RE: Proposed Dollar General Store  
Development Plan Control #201503020009

We received the development plan application review letter dated March 13, 2015. The following responses are provided to assist in the review of the enclosed re-submittal documents.

# DOLLAR GENERAL - GROVE CITY, OH (HOME RD)

03/24/15  
 Sheet  
C-4

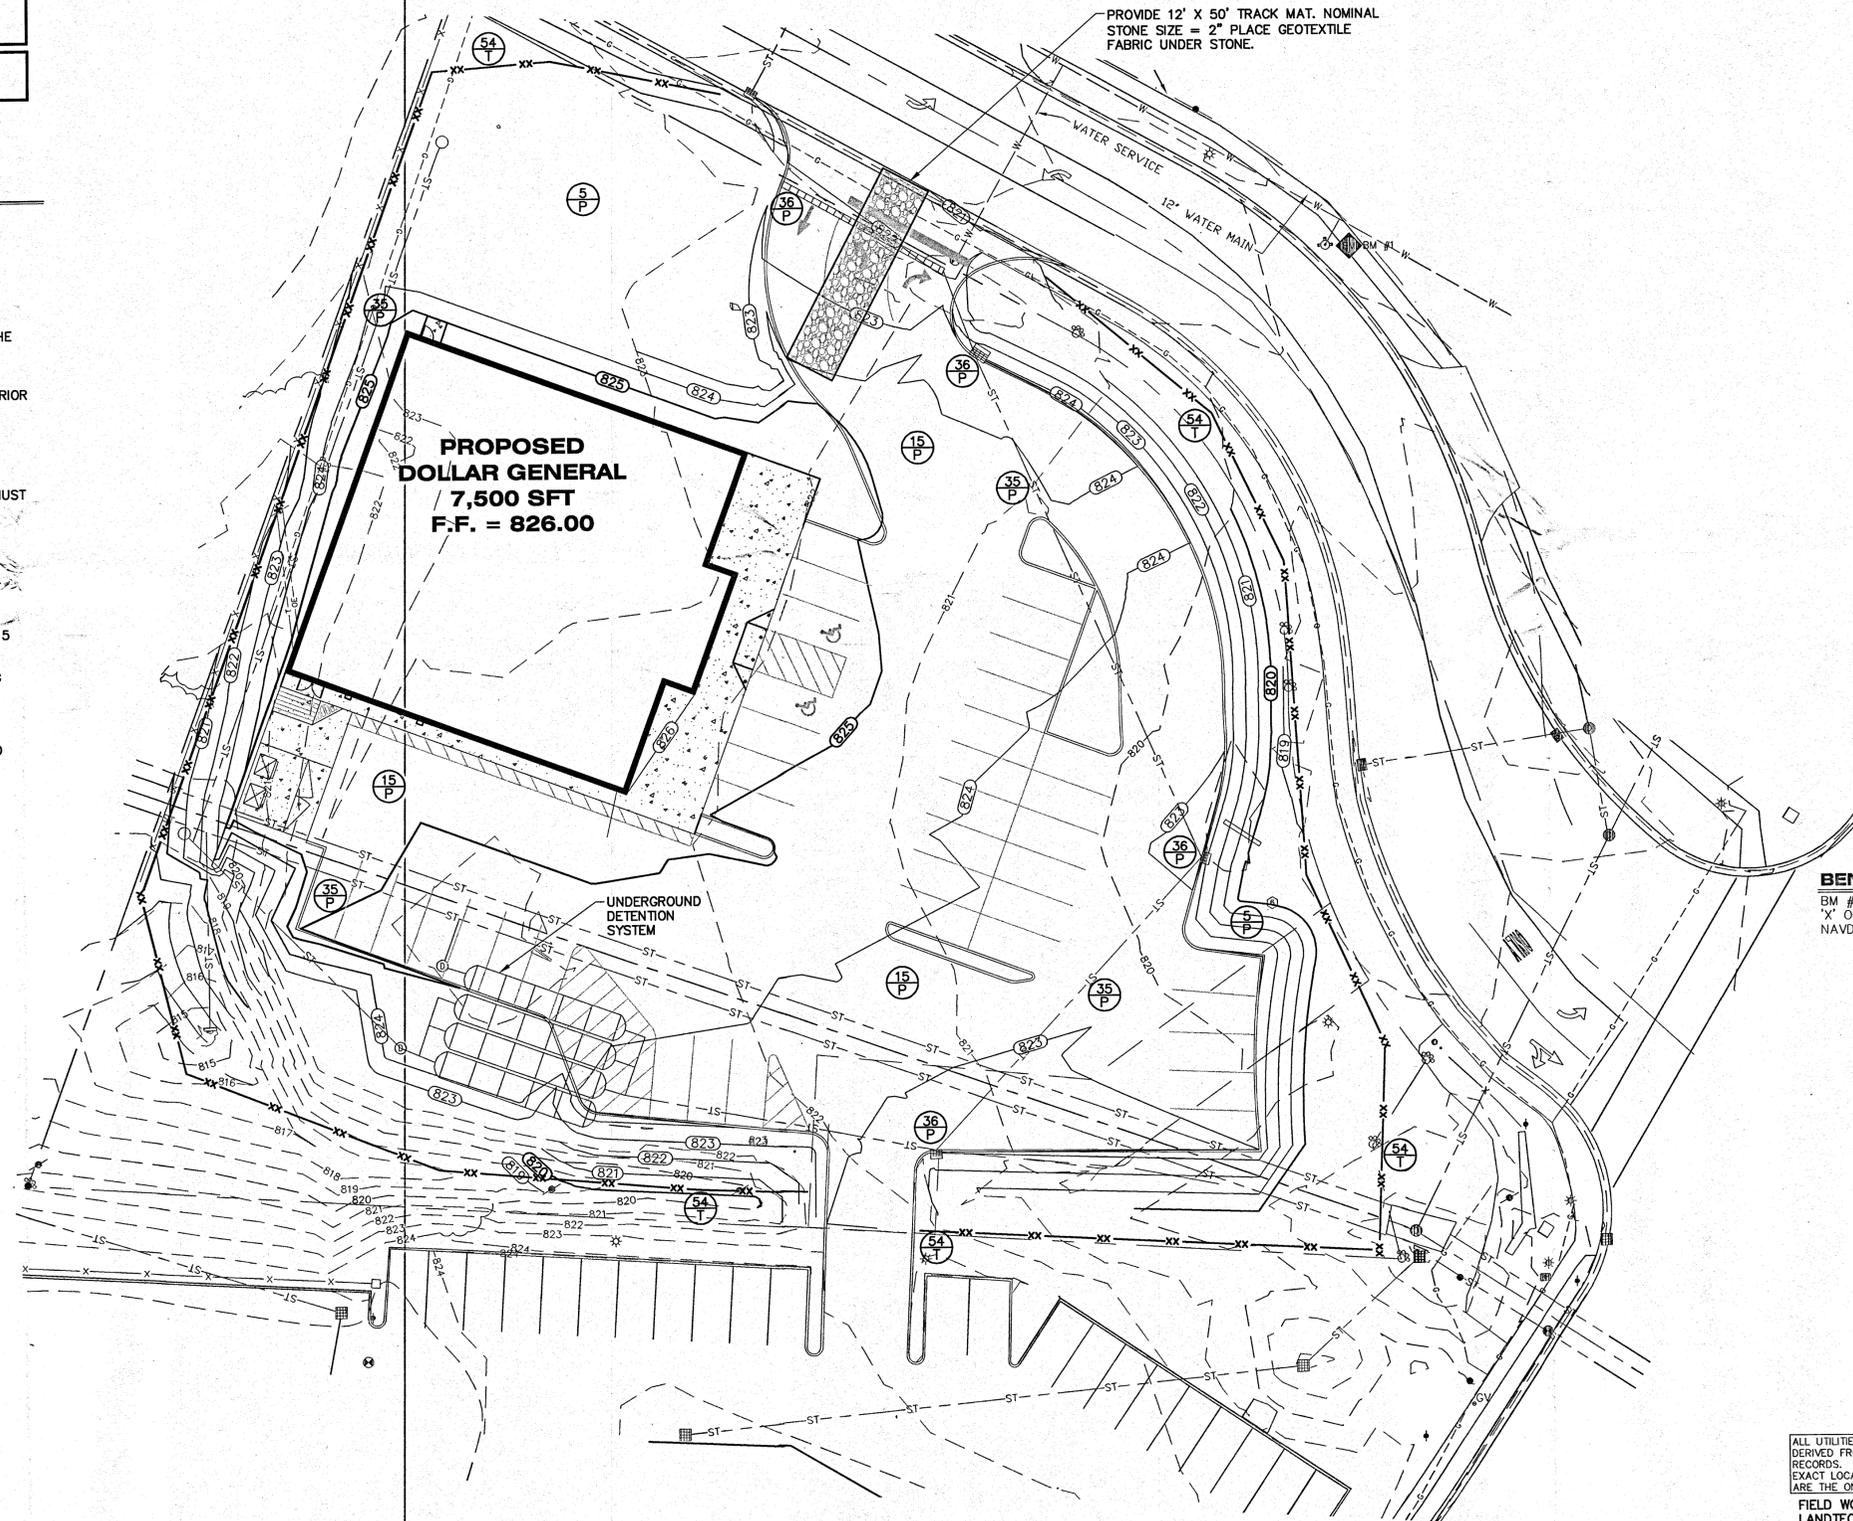
12. Turn lanes and arrows on Home Road are shown on Sheet C-1.
  13. The right-of-way and existing entrances on the north side of Home road are shown on Sheets C-1 through C-4.

**HANDICAP PARKING, ACCESS RAMP AND ACCESS AISLE DETAILS**  
N.T.S. (CANOPY OMITTED FOR CLARITY)

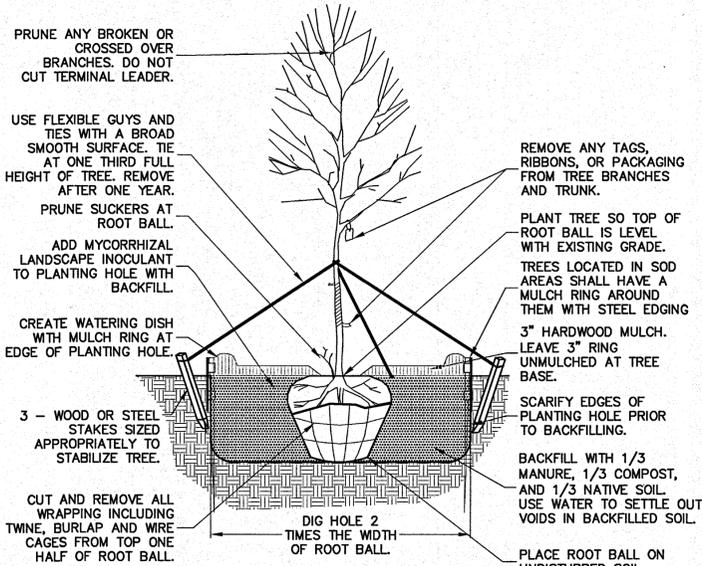
10. Sheet C-5 has been revised to show a handicap parking stall width of 9 feet.
11. Our discussions with the Grove City Building Department determined that the site is not within the Floodway as Baumgardner Ditch has been enclosed. The floodplain (base

Sheet Title:  
 Project:  
 Client:  
 03/24/15  
 Sheet  
 1-1

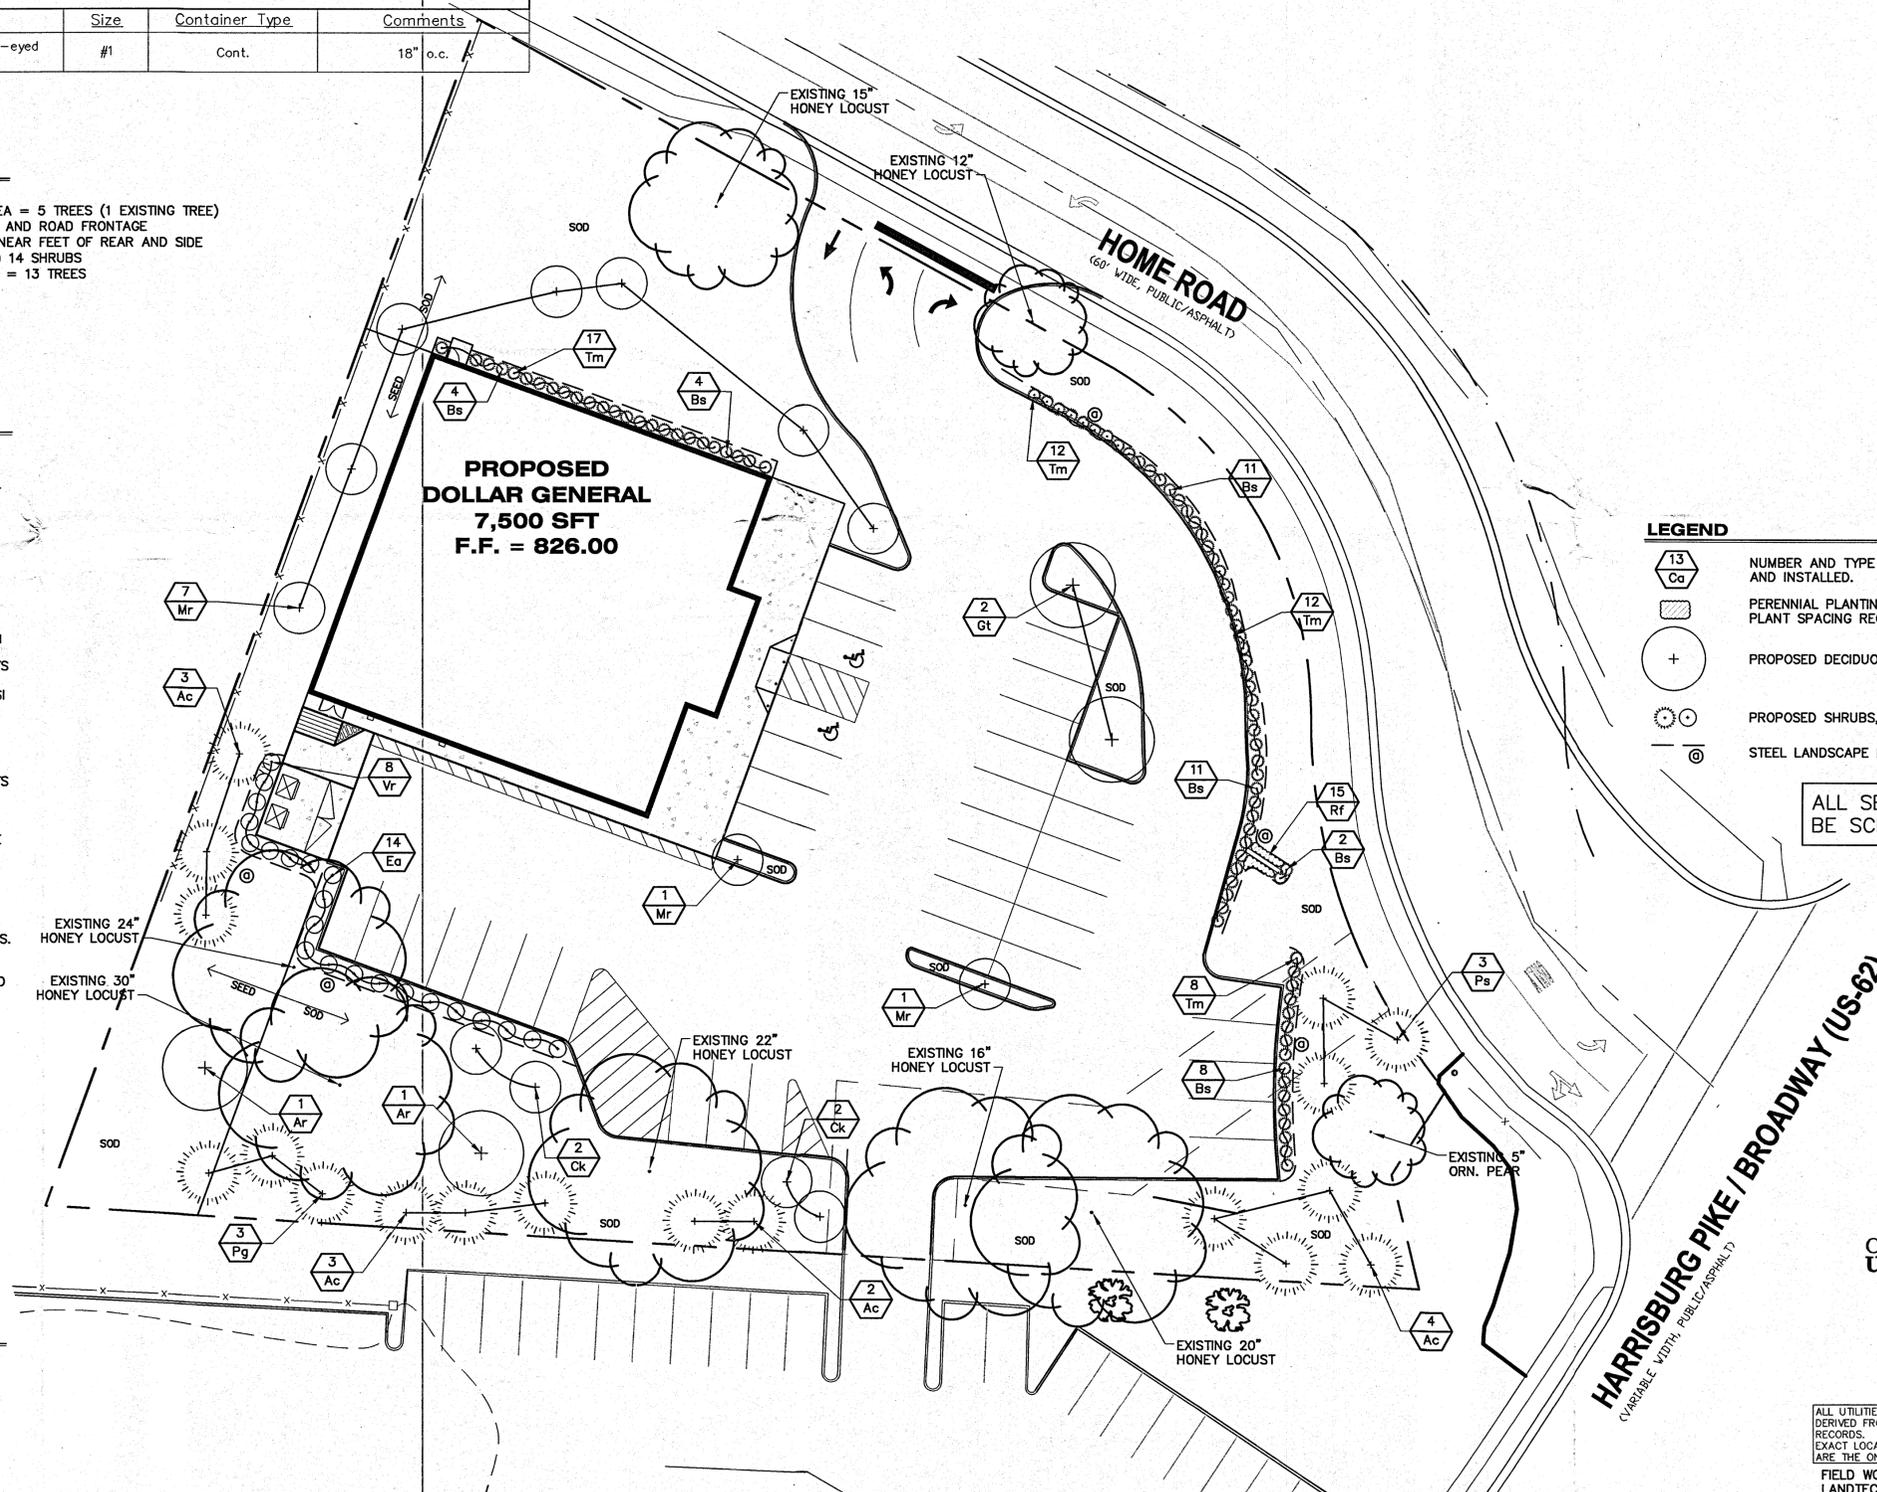
8. A landscaped island has been added to the south end of the central rows of parking spaces. See Sheet L-1.
9. The building has a total perimeter of 342 feet. This results in a requirement of seven (7) trees. These required trees are provided around the north and west sides of the building. Also, a landscape bed has been added along the north side of the building.

03/24/15  
 Sheet  
**L-2**

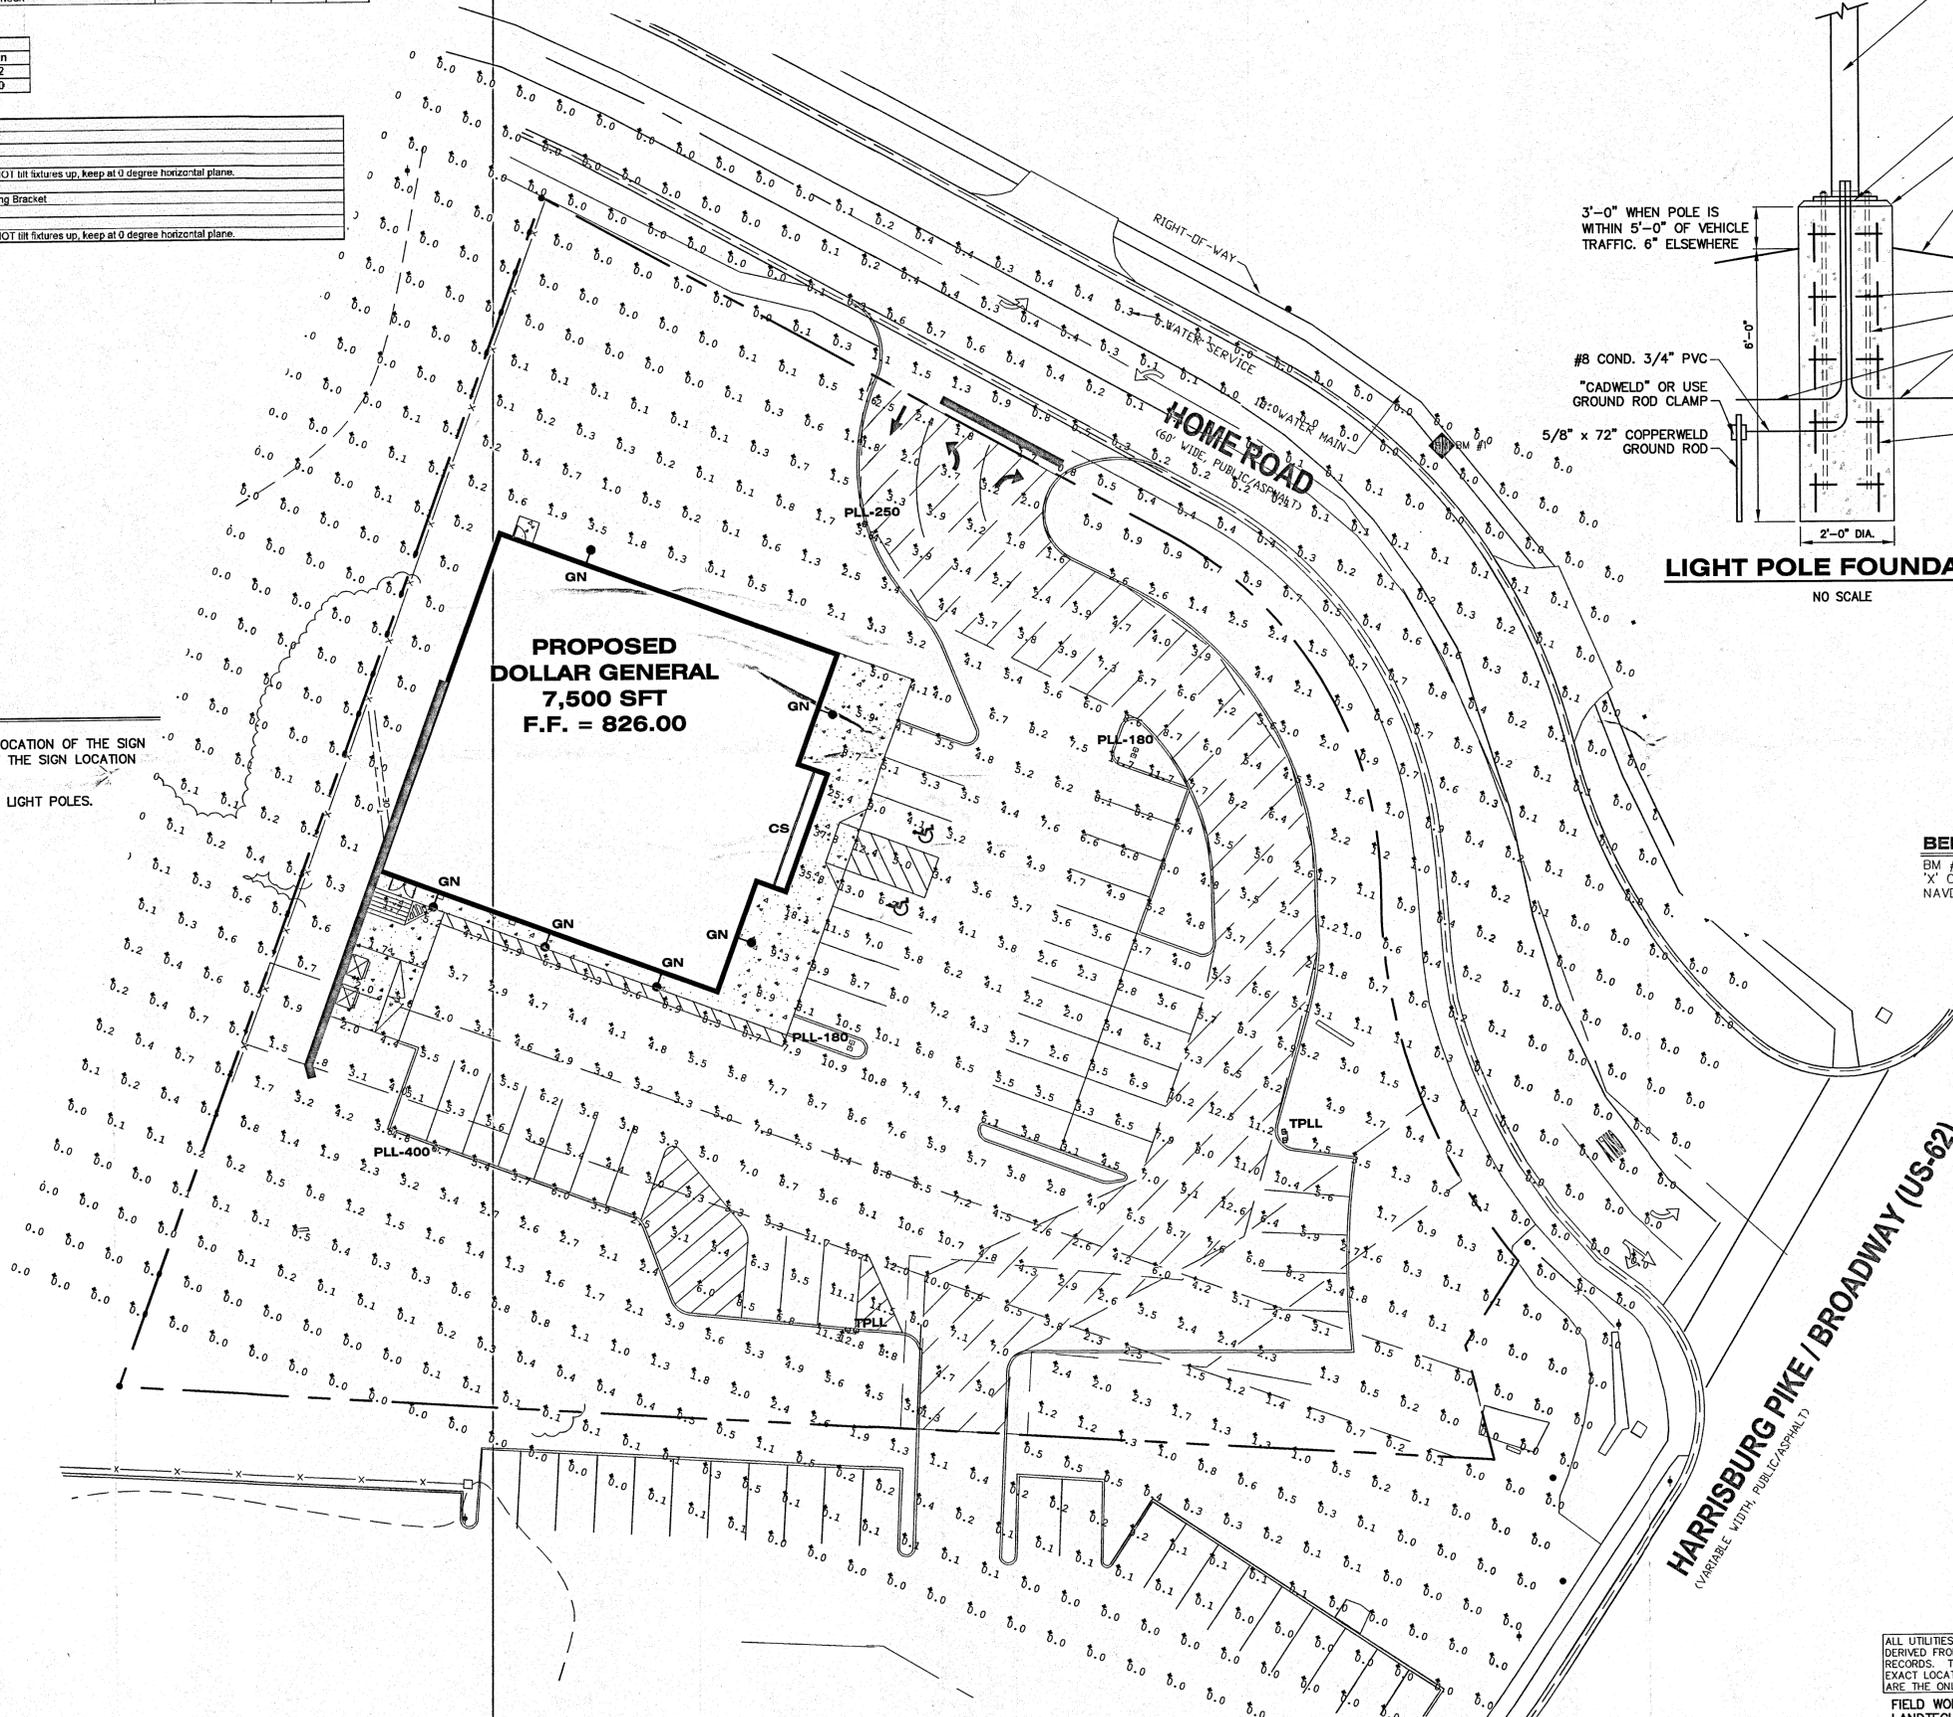
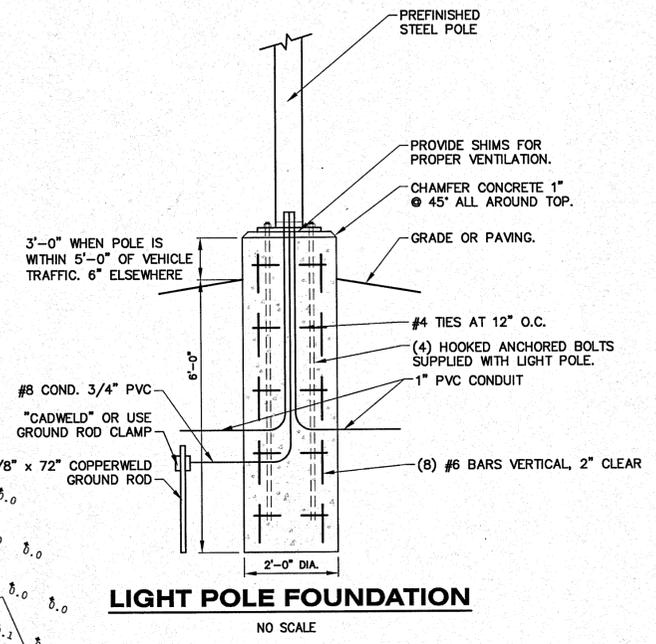
21. A light fixture is provided in the vicinity of each exterior service doors. The fixture locations photometrics are shown on Sheet L-2.
